SYDNEY WESTERN CITY PLANNING PANEL

COUNCIL ASSESSMENT REPORT

Panel Reference	2017SSW045
DA Number	DA-574/2017
LGA	Liverpool City Council
Proposed Development	Demolition of existing structures and the construction of four x 4-storey residential flat buildings containing 253 residential apartments, basement carparking and associated landscaping and torrens title subdivision, over two stages.
Street Address	484 & 488 BRINGELLY ROAD, AUSTRAL (LOT 7 DP 1203674 and LOT 6 DP 1203674)
Applicant	DREAMSCAPES ARCHITECTS
Owner	Austral Dwelling Pty Ltd / Happy Trading Pty Ltd
Date of DA Lodgement	2 August 2017
Number of Submissions	One (1) submission
Recommendation	Refusal
Regional Development Criteria (Schedule 4A of the EP&A Act)	The proposal has a capital investment value of over \$30 million
List of all relevant s4.15(1)(a) matters	<p>1. <i>List all of the relevant environmental planning instruments: s4.15(1)(a)(i)</i></p> <ul style="list-style-type: none"> • State Environmental Planning Policy (Sydney Region Growth Centres) 2006 (SEPP SRGC). • State Environmental Planning Policy No.65 – Design Quality of Residential Apartment Development (SEPP 65). • State Environmental Planning Policy N

Figure 5: Deep Soil and Communal Open Space Plans showing the 4 RFBs originally proposed

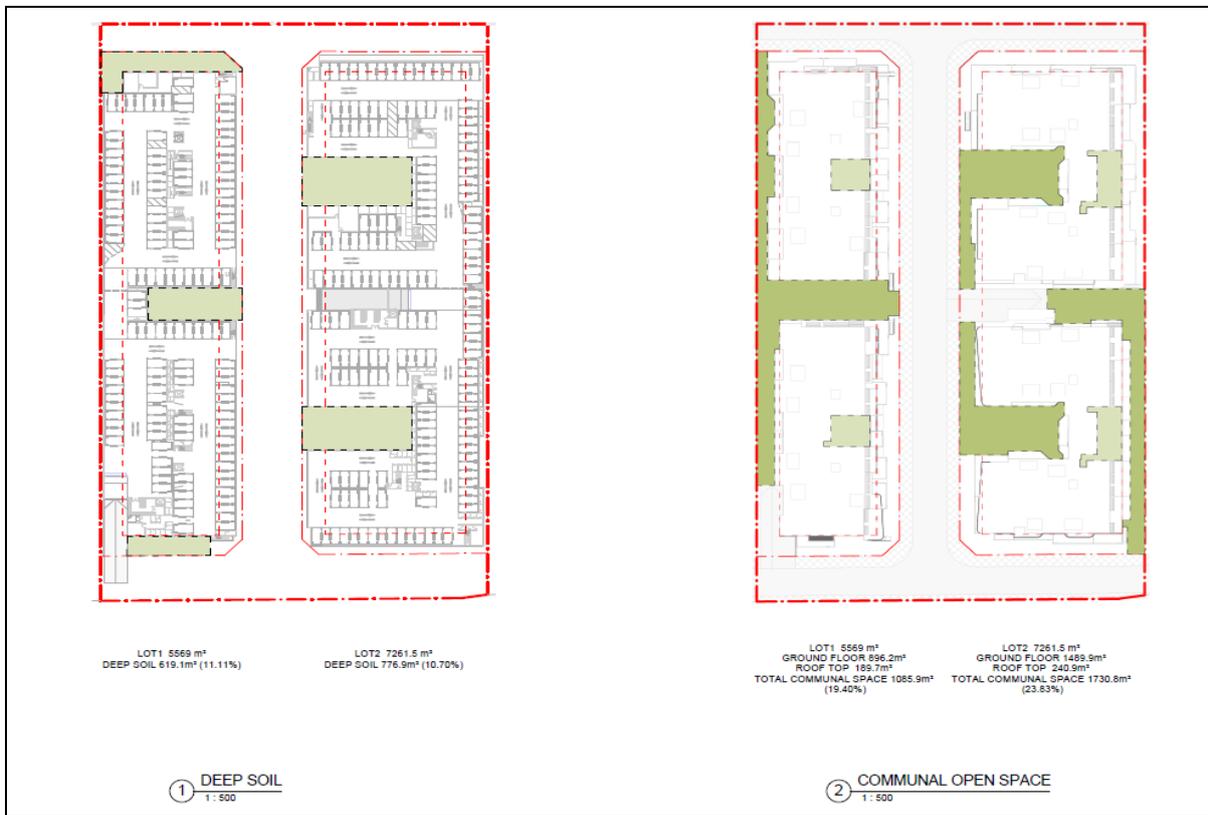
- 1) Figure 5 (DA lodged and assessed)**
145.29 dw/ha (four x 4- storey RFBs)
- 2) Figure 6 (Initial Downscaled concept)**
*Dwelling density not provided
(2 x 4 storey RFBs, 2 x 3 storey RFBs, 28 x 3 storey dwellings & 24 x 2 storey dwellings)*
- 3) Figure 7 (Second Downscaled concept)**
95.33 dw/ha (2 x 4- storey RFBs, 56 x 3 storey dwellings & 24 x 2 storey dwellings)

Figure 6: Initial downscaled concept option

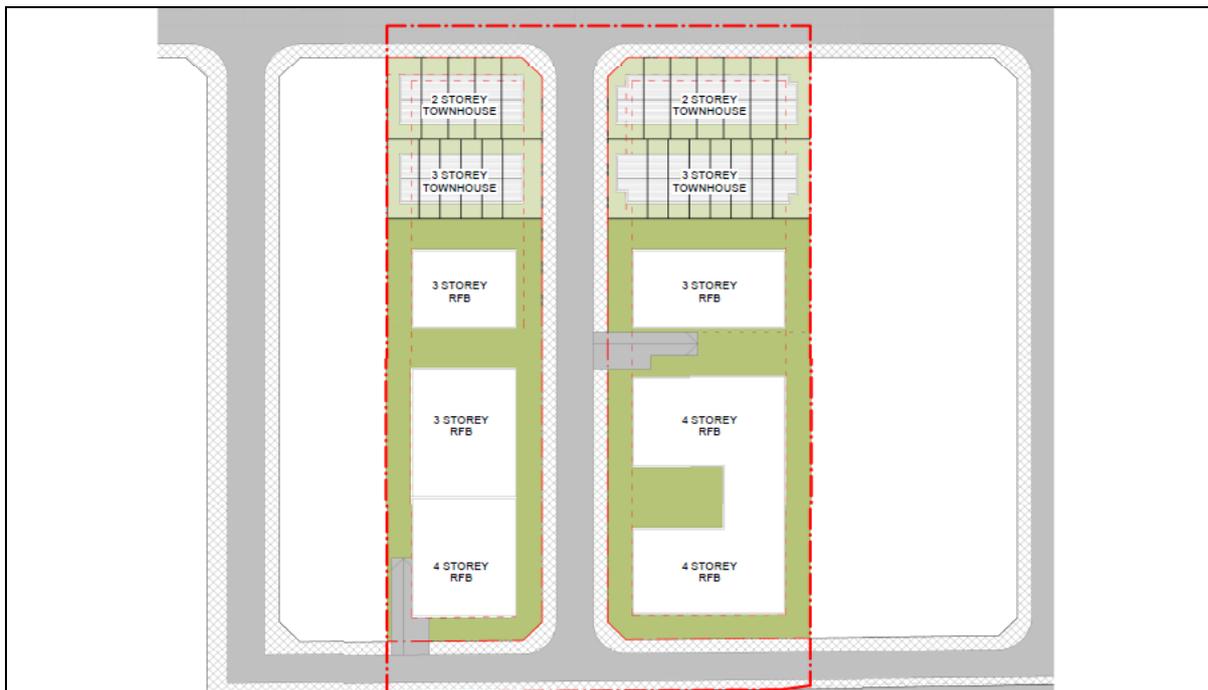
- vii) 13 February 2018
Applicant provided a response to the above correspondence in the form of a downscaled draft concept for the site (**Figure 6**). No technical details were submitted as requested.

Comment: As presented earlier in Section 3.1 of this report, the applicant provided only concept options in an attempt to address DEPs and Council's concerns. Although the overall residential typology was proposed to be amended, the overall residential density was considered too great, and the DA was not re-referred to the DEP.

Figure 7: Second downscaled concept option

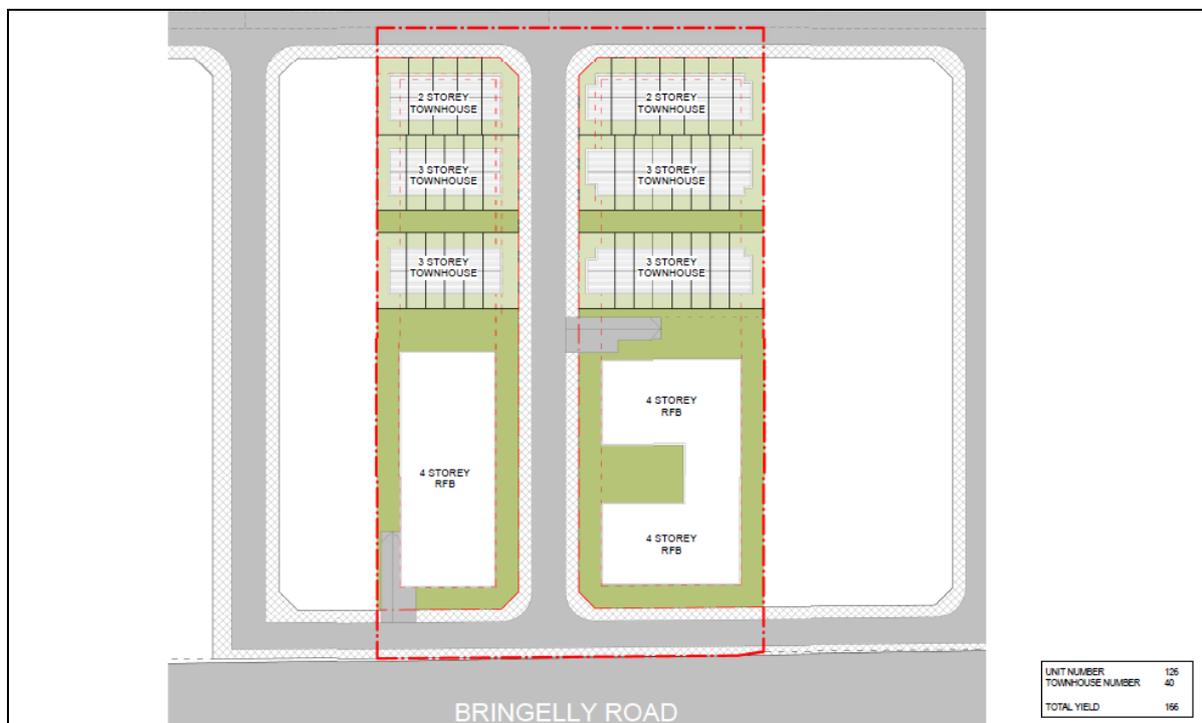
- ix) 6 July 2018
Applicant provided another downscaled draft concept for the site in response to the above meeting (**Figure 7**).
- x) 30 August 2018
Council requested the applicant withdraw the DA as it was not supportable, to which the applicant requested the DA be instead assessed and sent to SWCPP for determination.

Figure 12: Swale bypass (blue hatched) shown along western boundary in proposed location of a commonly accessed pathway and over communal open space.

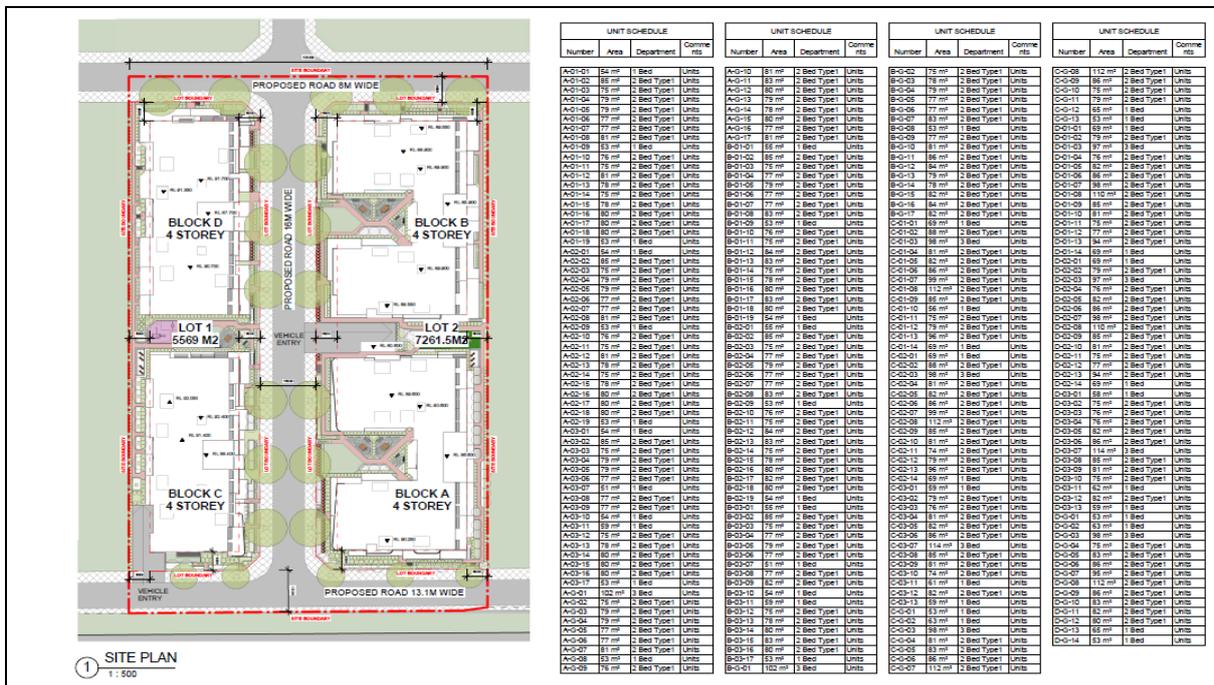
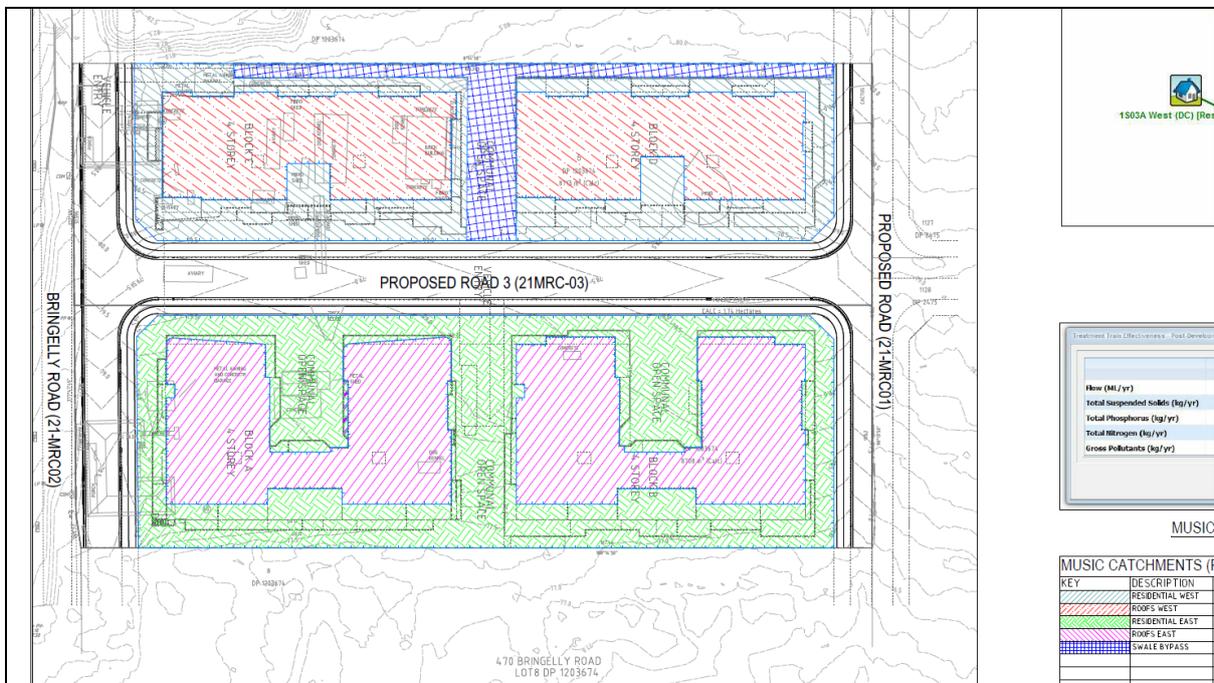
- iv) *Proposed drainage system through the communal space shall be revised/resized as required to capture flows from the swale up to the 20yr ARI events allowing the communal space is flood free. Revised stormwater drainage plans showing pipe sizing with hydrologic/hydraulic calculation shall be submitted.*

Note: As discussed in Section 3.2 of this report, Council's Land Development and Floodplain Engineers considered the proposed detail insufficient to assess compliance with Council's Flood and Water Cycle Management policies. Additionally, an adjoining owner's consent was required which was not provided, and which is required even if the stormwater concept is amended. An extract of the design infrastructure and calculations is shown in Figures 11 and 12.
